DEPARTMENT OF NATURAL RESOURCES  
DIVISION OF OIL, GAS AND MINING

RE: Site Inspection, Hub Research and Development Company, Bret Clark Mine, S/015/043, Emery County, Utah

**Photographs  
S/015/043  
Bret Clark Mine**

Photo 1. Product stockpile.

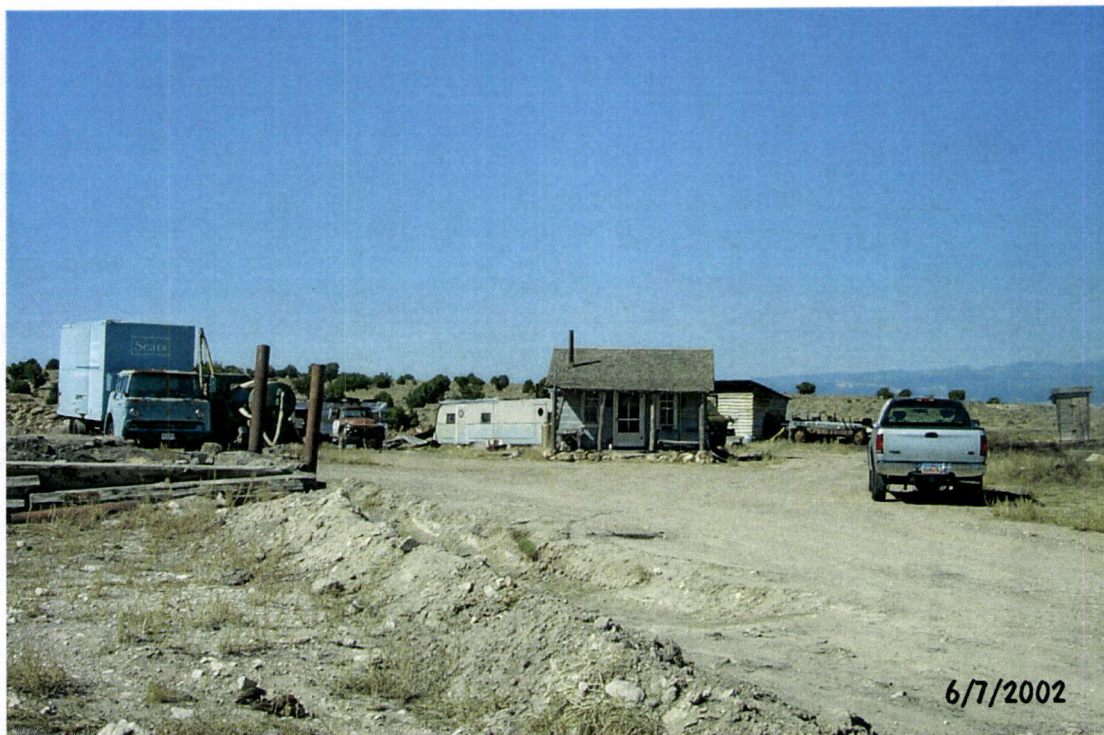
The site has three levels. Items and facilities on top of the plateau include a product stockpile (Photo 1), a log cabin office building, a shack, a trailer, a Sears delivery truck, an outhouse, and various other equipment and scrap (Photo 2). The second level is mainly a road, and the portals are on the lower level.
